Service Bulletin

Subject: **Clutch cable**

Product: **F3 800 ROSSO\F3 800 RR EURO 5**
VIN list attached at the end of the document

As a result of continuous monitoring of our product quality, it has been found that on the above specimens it is necessary to replace the clutch cable with an optimised component part no. 8000D1068.

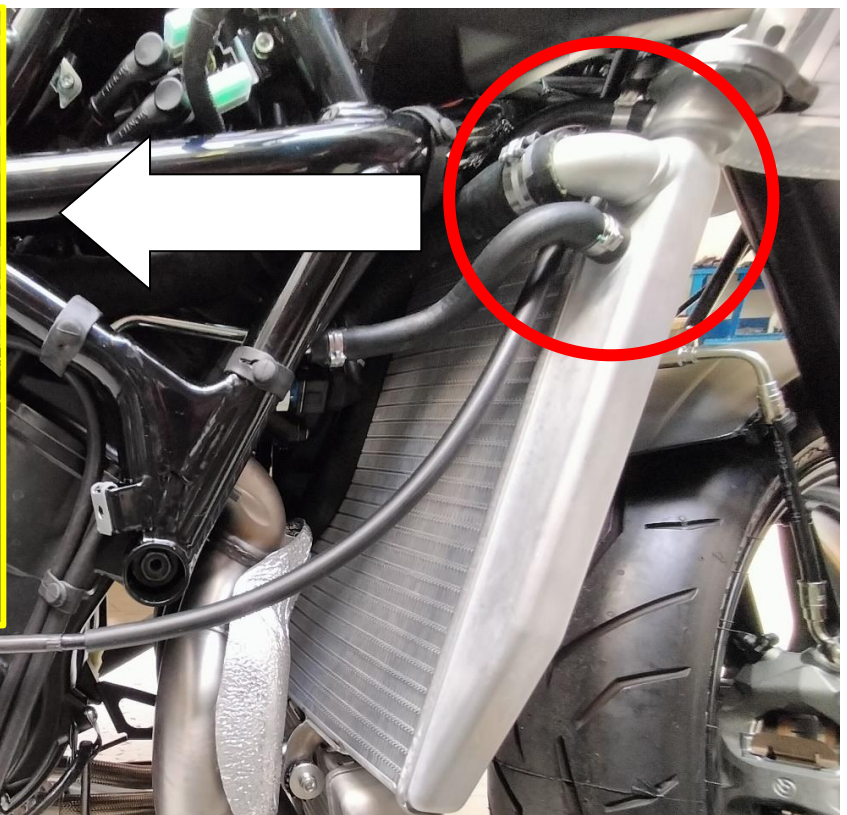
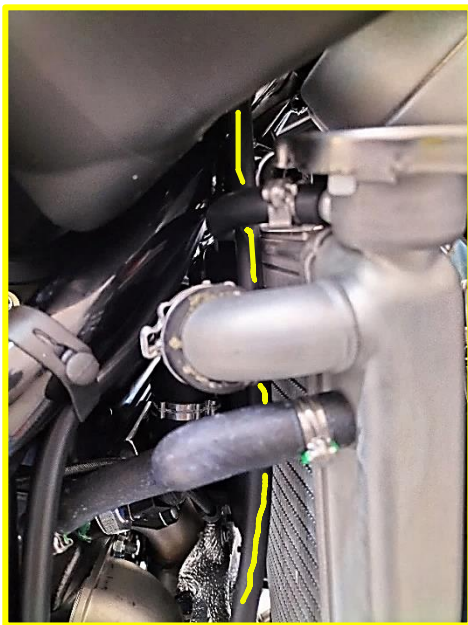
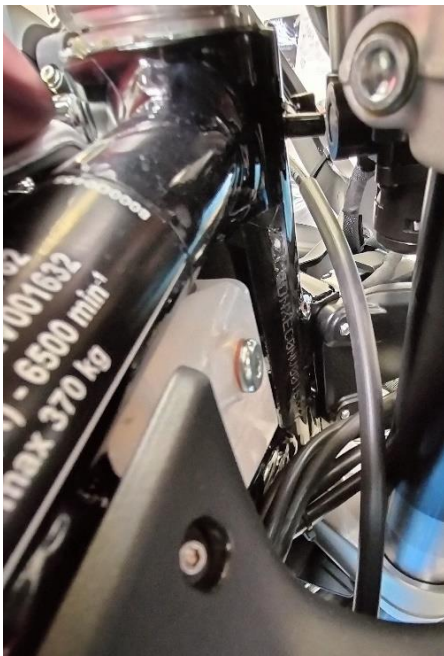
- Remove the right-hand fairing.
- loosen the two nuts that fix the clutch cable to the cable support plate part no. 8000B4678.
- Release the clutch cable from the clutch release shaft part no. 8000B8987.
- Remove the clutch switch connector away from the cable by removing the two rubber clamps present.
- Remove the cable from the housing on clutch switch part no. 8000B8974.
- Pull the clutch cable out, paying attention to its routing.
- **NOTE: The clutch cable removed MUST NOT BE USED AGAIN.**
- Take the new clutch cable part no. **8000D1068** and place it on the vehicle, paying attention to its routing; check the correct routing by referring to the pictures below:

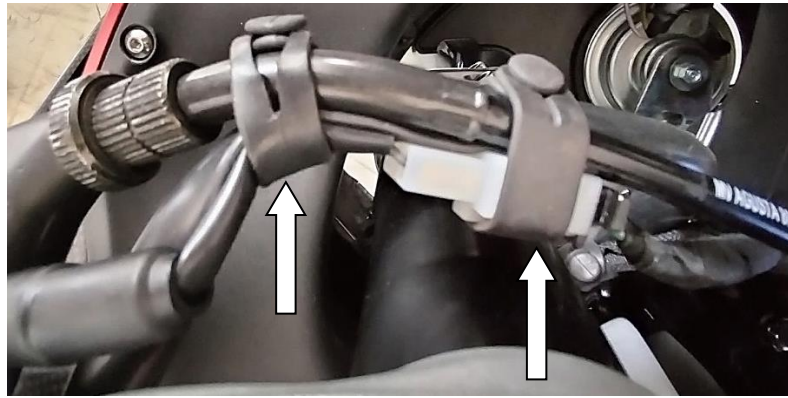
- Tighten the two nuts securing the clutch cable to the cable support plate part no. 8000B4678 to a torque of 10 Nm.
NOTE: pay attention to the orientation of the metal cable guide; orient it so that it moves the clutch cable as far as possible away from the exhaust manifold and with a distance from the right fairing of 4 mm:
